#### 5-7 Lawrence Street and 18 Marmora Street, Freshwater

#### Section 96 Stormwater Assessment

Title	Section 96 Stormwater Assessment		
Location	5-7 Lawrence Street and 18 Marmora Street, Freshwater		
Description	Section 96 application to modify NSWLEC 1098		
Primary Contact	Russell Druce		
Authors	Russell Druce		
Reviewed by	Wade Prendergast		
Revision and Date	P1	29th May 2013	
Issued to	Frank Minnici

Refer Drawing DAH-03/P6 mark-up which show proposed staging boundary and separate stormwater systems

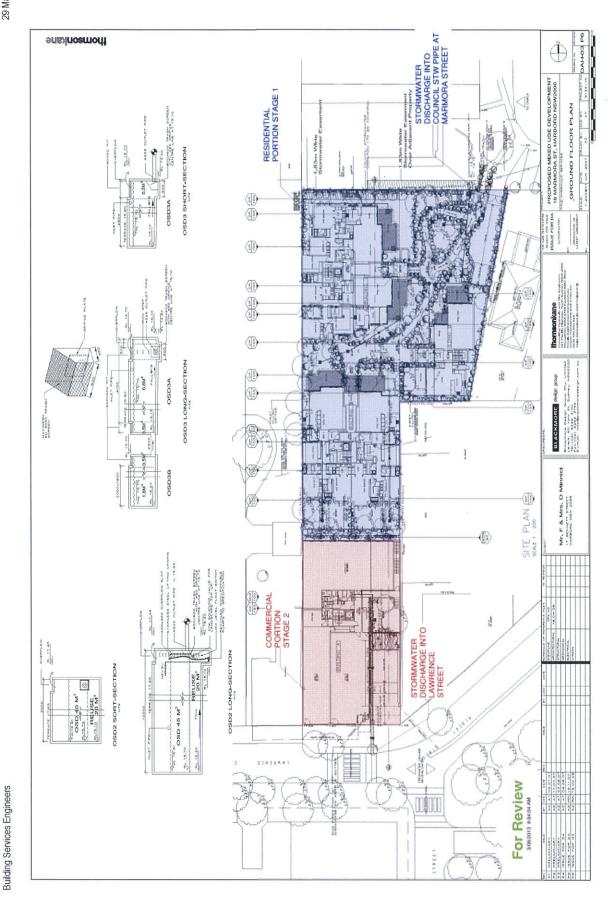
Stage 1 (Residential Construction) is shown hatched in Blue.

Stage 2 (Commercial Construction) is shown hatched in Red.

Based on the nature of the site and the current design which shows a stormwater discharge on both sides of the site, BSE are of the opinion that a staged development would have no effect on the current design and DA consent.
